**Calaveras County Water District
Copper Cove, California
Bidding Documents
Lake Tulloch Intertie Project
ADDENDUM NO. 1
Issued June 24, 2026**

COPPER COVE WATER SYSTEM IMPROVEMENTS PROJECT -
LAKE TULLOCH INTER-TIE

G02

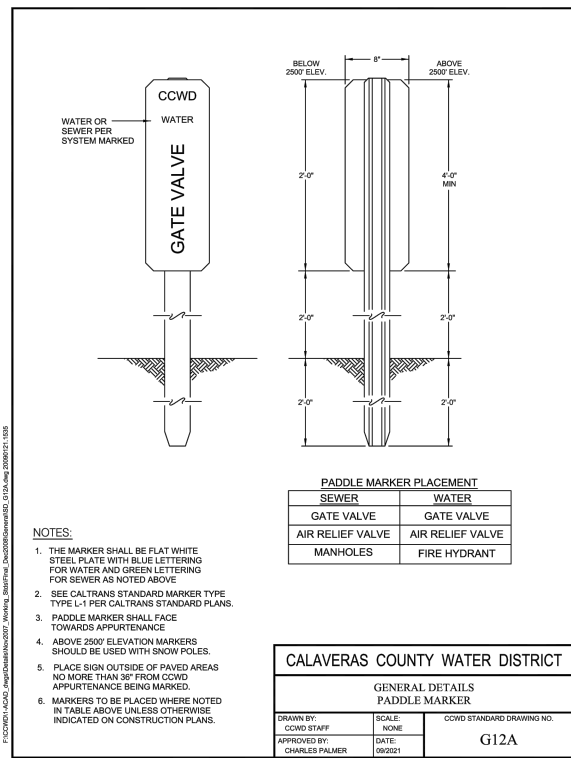
Question #5: Has potholing already been completed? Is potholing included in the bid schedule?

Response #5: Potholing was performed during design to identify potential utility conflicts. The potholing results can be found on Sheet G02 of the project plans. Please note, the Contractor is required to pothole all tie-in locations. Any additional potholing required will be paid under Bid Item No.1 – Mobilization/Demobilization.

PRESSURE REDUCING STATION **1**
 NTS C04

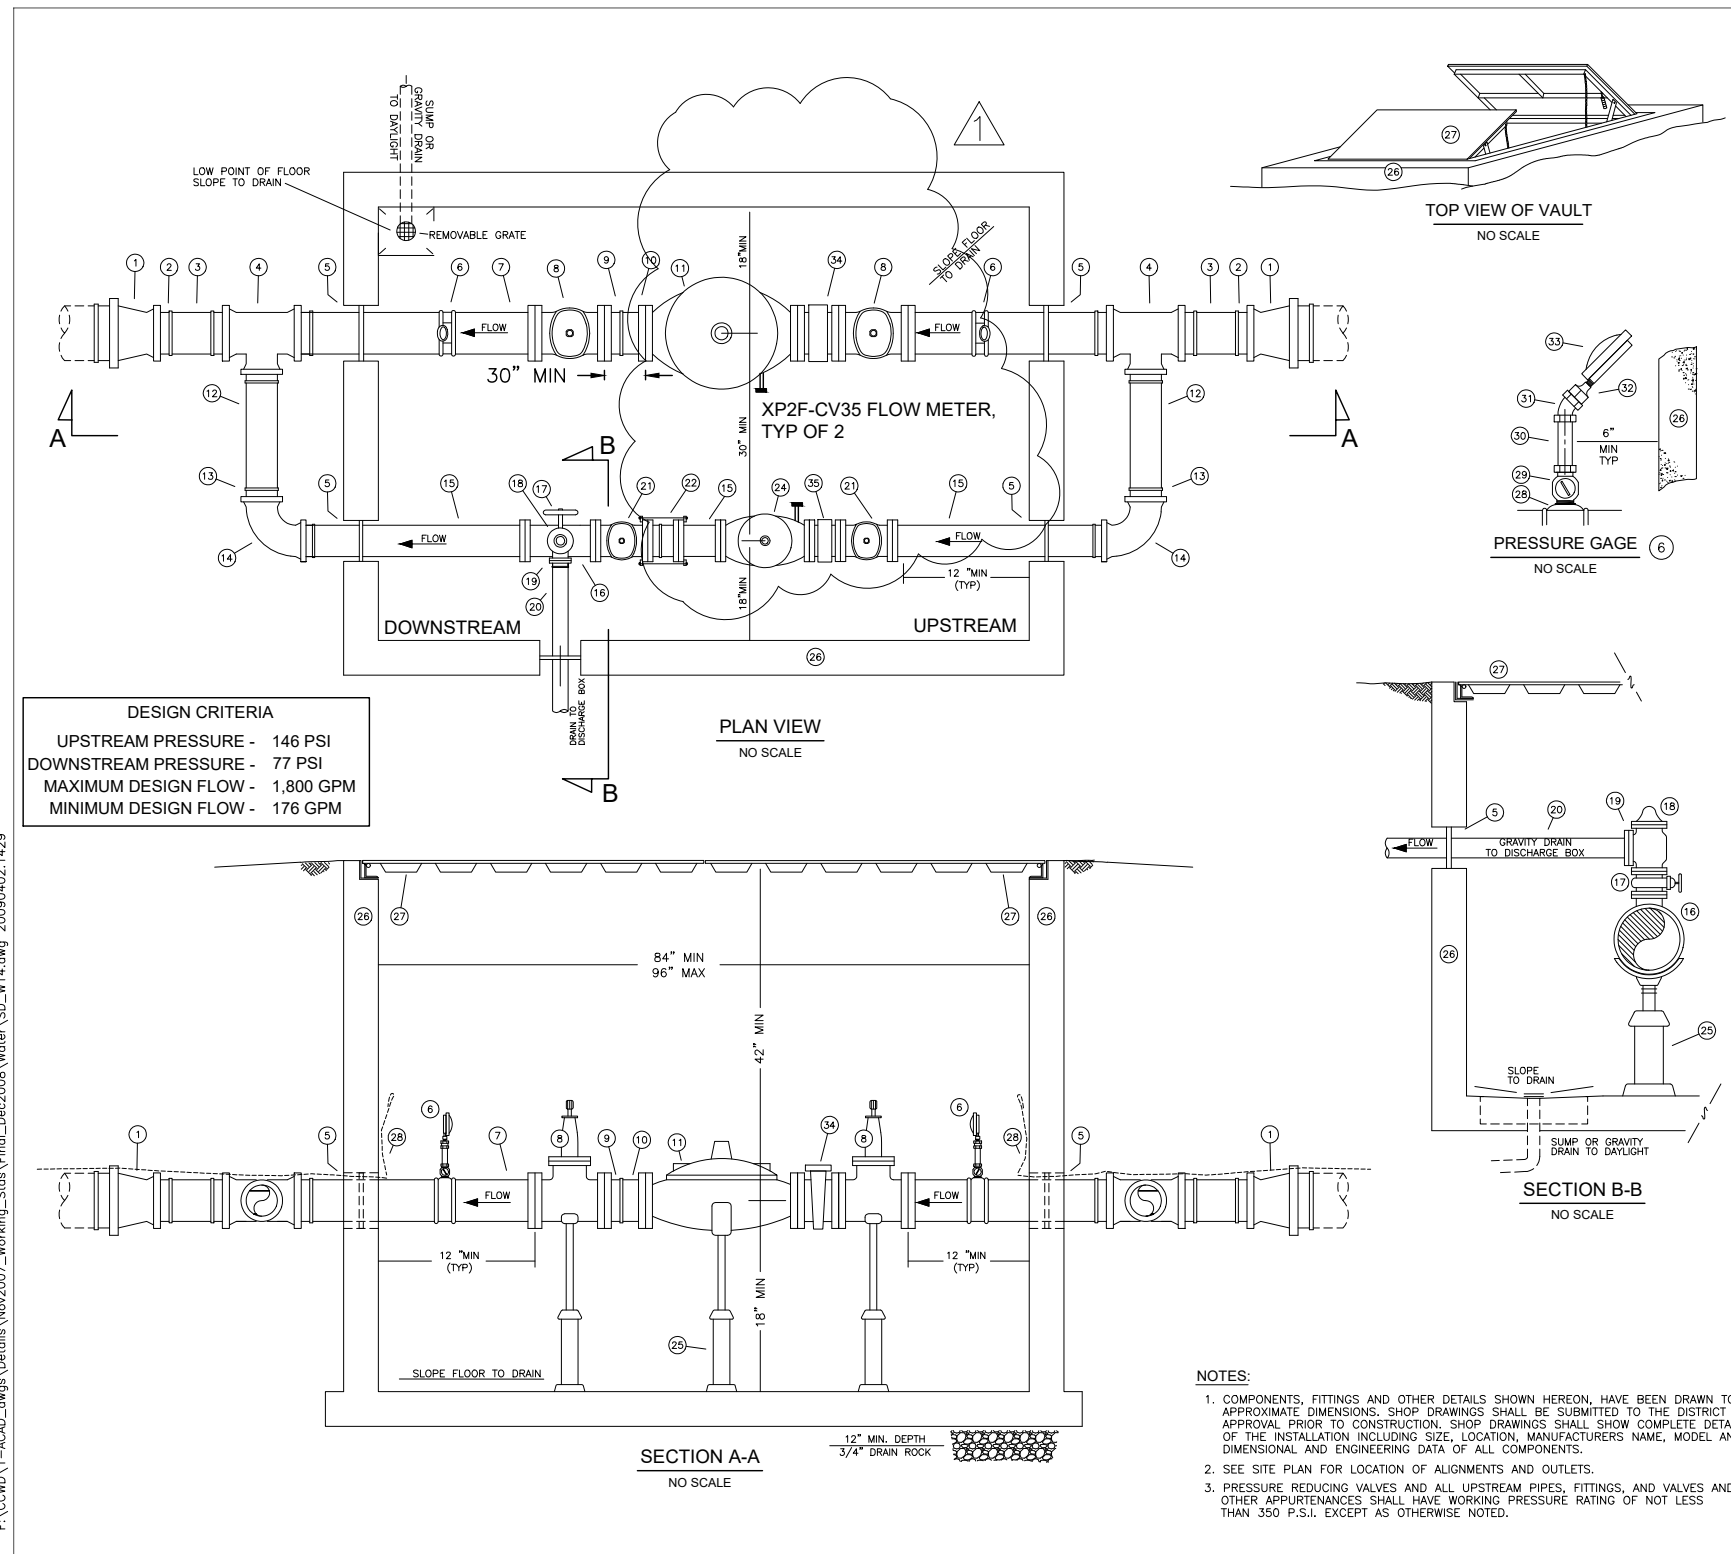
Question #14: On plan sheet C21 (see attached) and in the bid item descriptions there is a reference to a flow meter required at the PRV station. However, there is nothing shown on the pipe schematic or the items description table on the right-hand side of this sheet showing this meter. Please clarify.

DETAIL HAS BEEN MODIFIED TO SHOW TOP OF VAULT FLUSH WITH PAVEMENT AND REVISED BYPASS LINE.

Response #14: Provide and install two (2) XP2F-CV35 Cla-Val battery-powered flow meters: one on the main PRV and one on the bypass PRV, in accordance with Specification Section 33 14 19.02, 2.01.F.1.
